MOORE, 1990

May Creek Culvert Outlet

Looking up into May Creek culvert outlet

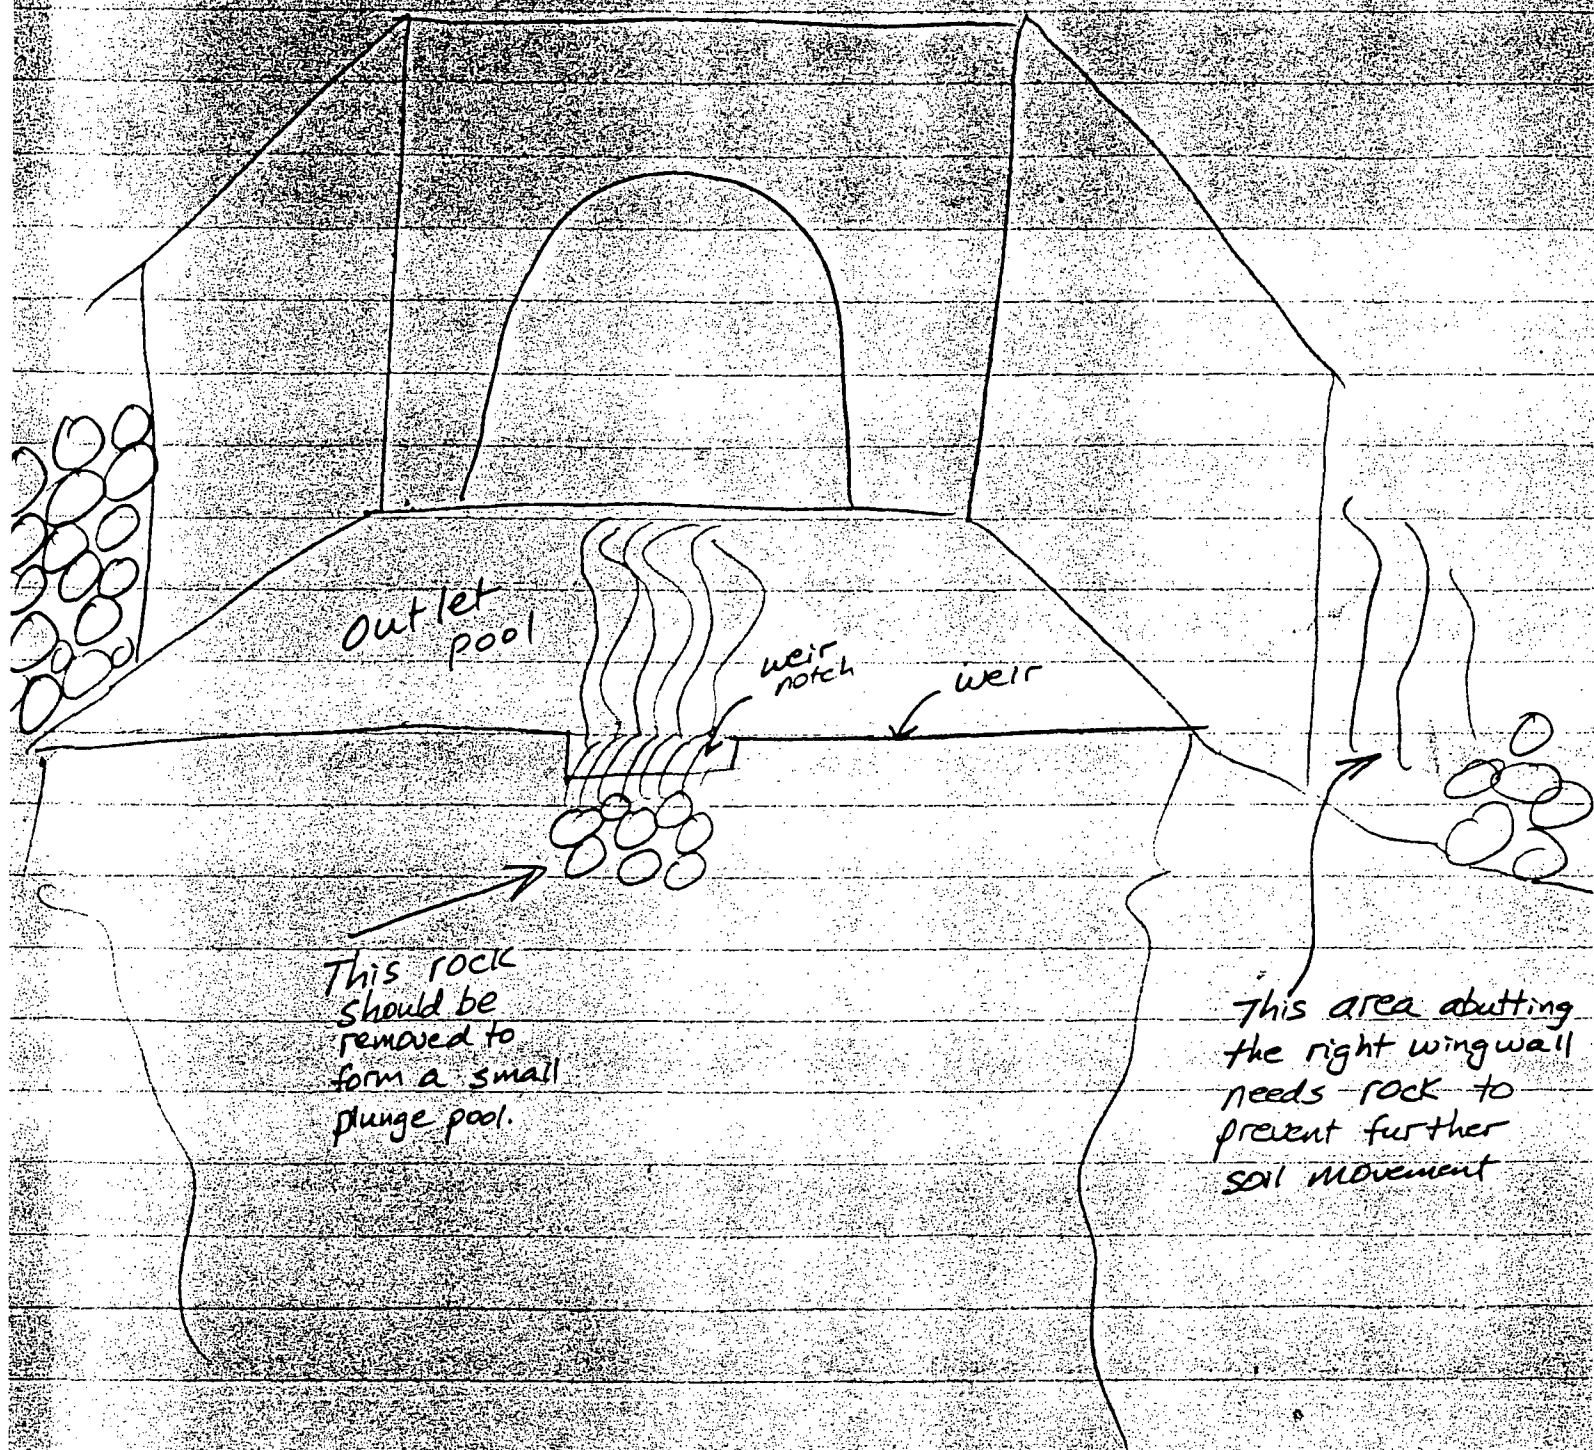
The right wingwall at the outlet looks like it could use some light RSP replaced to prevent soil movement. Also, the RSP at the location immediately below the outlet weir should be moved to create a small pool instead of the current rocky splash apron. This will assist Coho in their upstream migration. Can we get this done before next fall?

This rock should be removed to form a small plunge pool.

This area abutting the right wing wall needs rock to prevent further soil movement
